REGULAR CALENDAR  
STAFF REPORT AND PRELIMINARY RECOMMENDATION

Application No.: 6-96-45

Applicant: City of San Diego  
 Metropolitan Wastewater Dept.

Description: Construction of shoreline protection works including a rock revetment at the base of the bluff and a 30 foot-high, 176 foot-wide, tied-back shotcrete wall on the upper bluff, the installation of a 24-inch pipeline storm drain system and the construction of a 100 space parking area at an adjacent vacant, 4.2 site to the north. Grading for the proposals will involve approximately 6,037 cubic yards of cut and approximately 7,427 cubic yards of fill.

EXHIBIT NO. 3
APPLICATION NO. <b>6-96-45</b>
Project Specific Site Plan

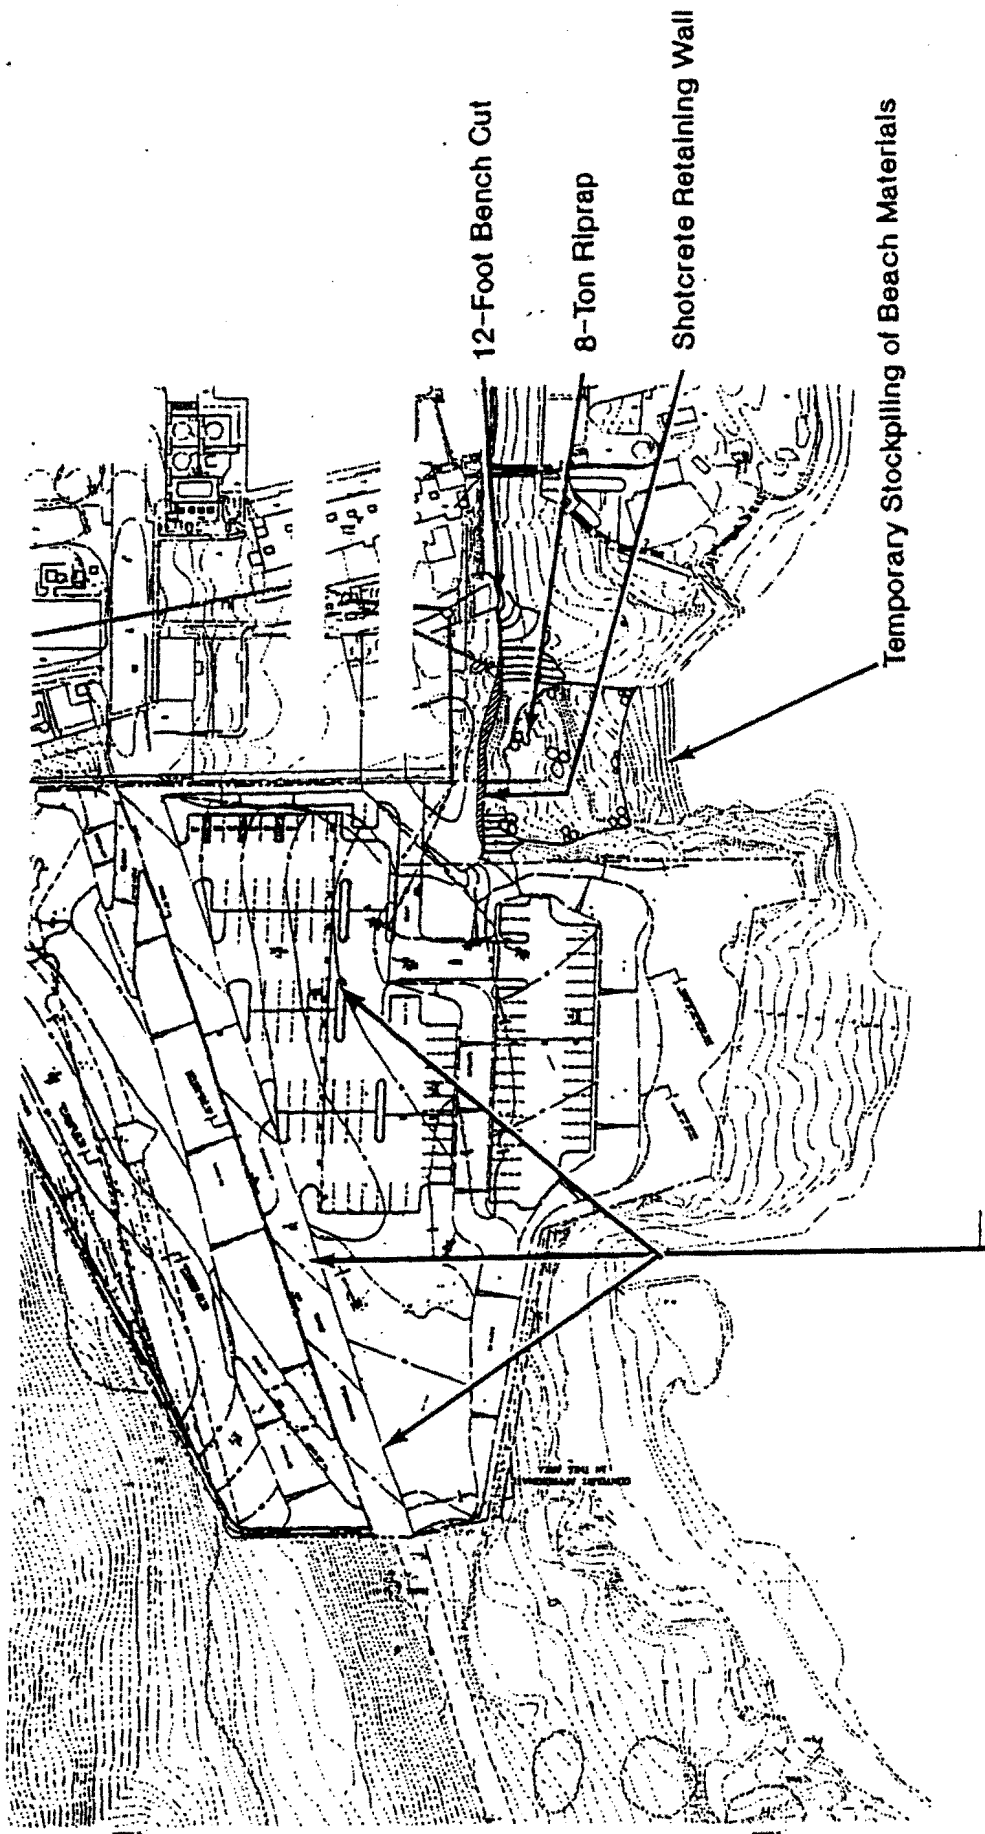
1. Waiver of Future Shoreline Stabilization. The permittee shall not construct shoreline stabilization projects along the shoreline west of the 4.2-acre North Parking Facility site, as shown on exhibit 2, to protect the proposed parking area. Any proposed development at this location which becomes threatened in the future is considered expendable and shall be removed.

EXHIBIT NO. 6
APPLICATION NO. <b>6-96-45</b>
North Parking Facility Plan View With 50-75 Year Retreat Lines
California Coastal Commission

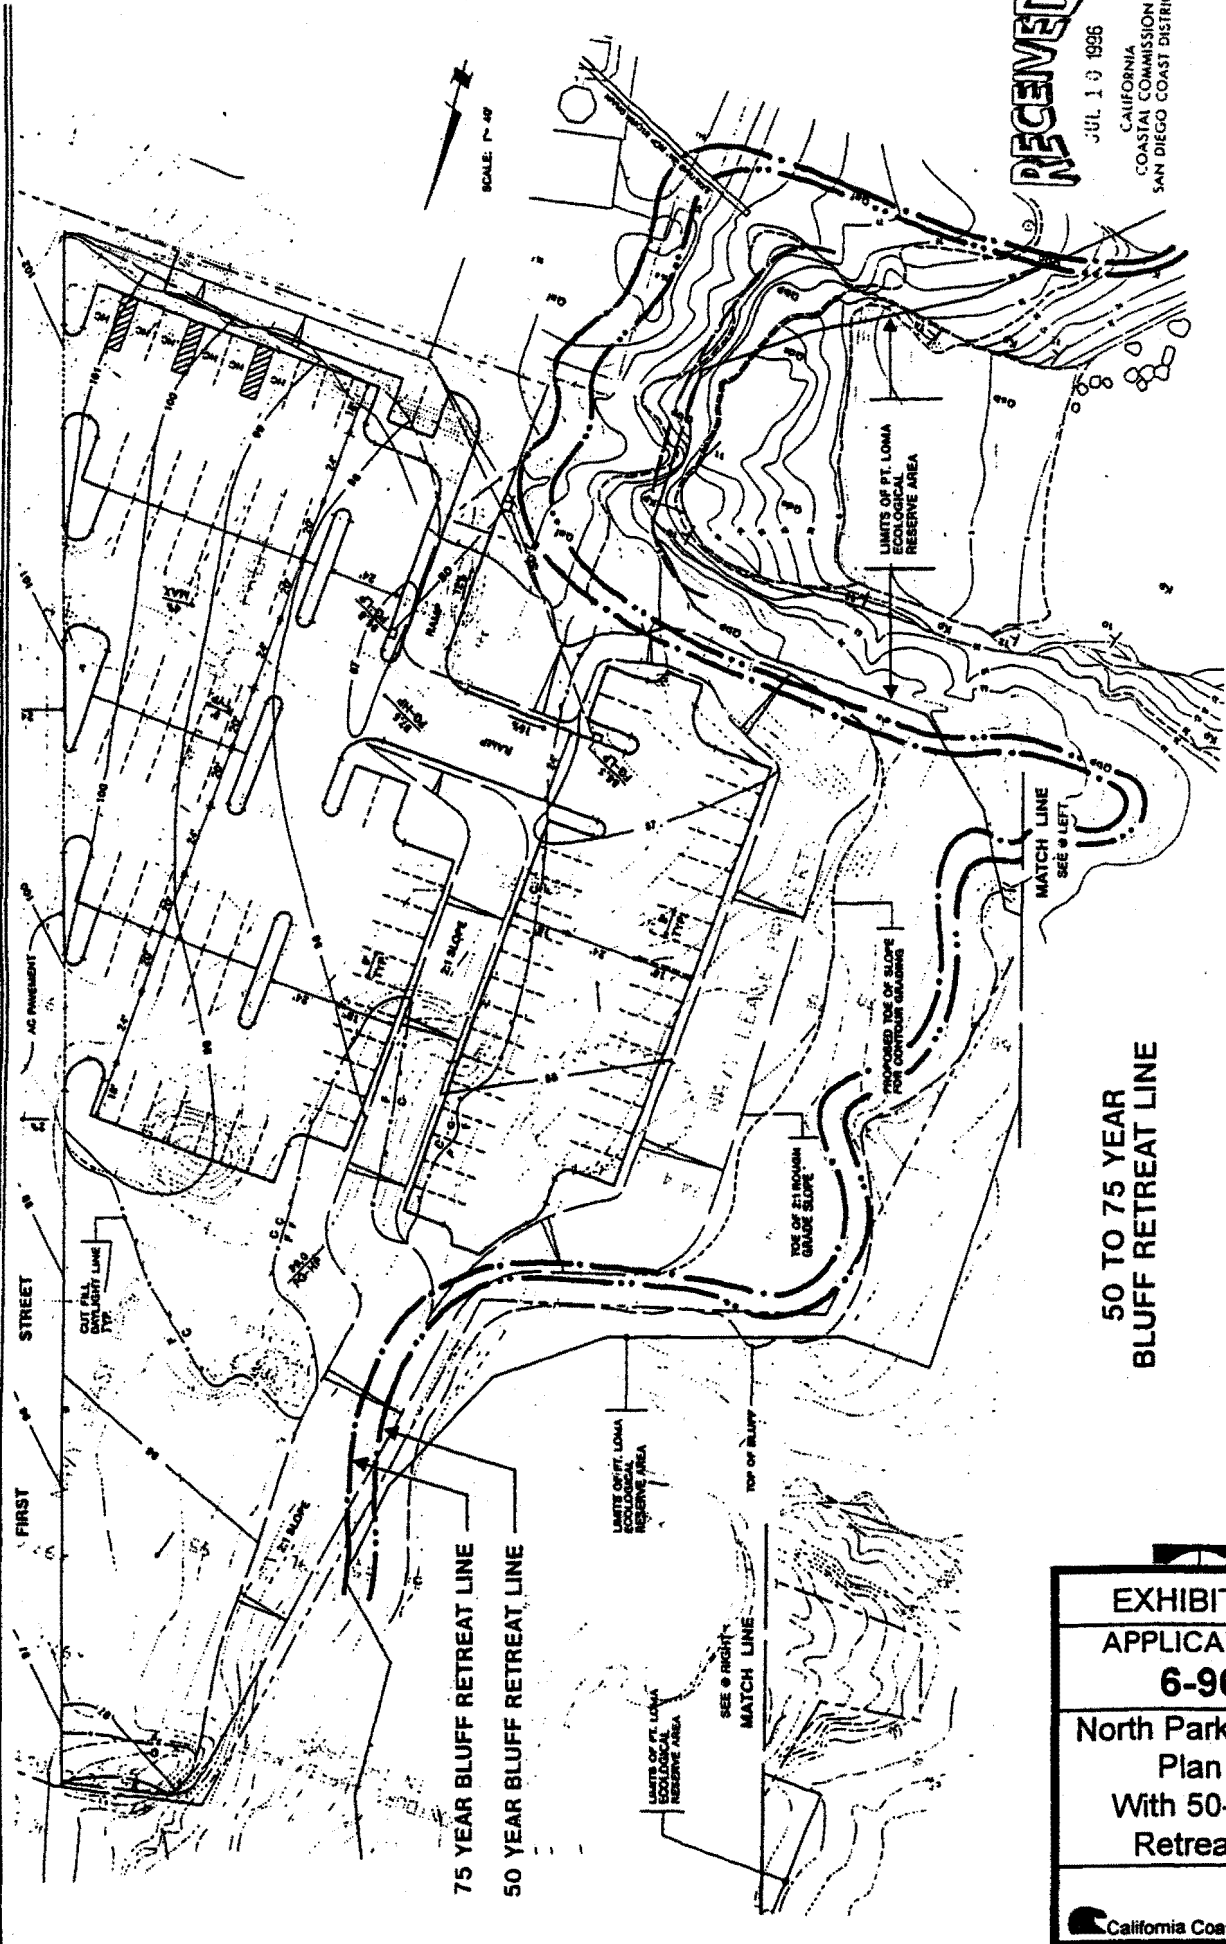
a. Revised grading and construction plan which shall indicate that no development at the North Parking Facility will occur seaward of the 50-year bluff-retreat line as identified on the "50 to 75 Year Bluff Retreat Line" Map dated July 10, 1996.

The second project proposed under this application is the construction of a 100 space parking lot and construction staging area. The approximately 4.2-acre site is located directly north of the existing northern boundary of the PLWTP and, therefore, directly north of the proposed shoreline protection devices. The property is in the process of being transferred to City ownership from the U.S. Navy. The City has had an on-going lease arrangement with the Navy for use of the property for construction staging and parking for the past several years. Approximately 3/4 of the eastern portion of the site is highly disturbed, has been graded and has no vegetation. The remaining northern and western portion of the site is covered with ice plant and other invasive species. The applicants propose to grade and recontour the existing site to blend into the natural coastal setting, construct a 100 space asphalt parking area in the southwest corner and landscape the site with native vegetation. The grading and construction plans submitted with the application indicate that the toe of the proposed graded slope for the parking lot will at some points lie within 2 feet from the edge of the bluff. This proximity to the bluff is inconsistent with Section 30253 of the Act which prohibits new development which would in any way require the construction of protective devices. The applicants have proposed a redesign of their proposal to conform to Section 30253 and will revise their plans to ensure that development will not occur closer than 10 feet from the edge of the bluff. This 10-foot location conforms to the 50 year retreat line projected for the site by the "50 to 75 Year Bluff Retreat Line" map submitted by applicant's geologist. Since the revised plans have not yet been received by the Commission, condition #2(a) has been attached. This condition requires the applicant to submit revised plans for the parking lot and construction staging area indicating that no development will encroach beyond the 50-year bluff retreat lines as identified on the "50 to 75 Year Bluff Retreat Line" map submitted to the Commission on July 10, 1996.

As indicated above, Section 30253 of the Act provides that new development not require the construction of protective devices that would substantially alter natural landforms along bluffs and cliffs. The "50 to 75 Year Bluff Retreat Line" map submitted with the application indicates the parking area could be subject to bluff failure within 50 years. However, the applicants have stated they do not consider the proposed parking lot a "principal structure" and will not seek protection for it in the future. Condition #1 assures that development is consistent with Section 30253 in that the applicants agree to not request the construction of protective devices in the future in the event the parking area is undermined. In addition, if any of the permitted north parking facility site is threatened by future coastal erosion, the applicants agree to remove those threatened sections.
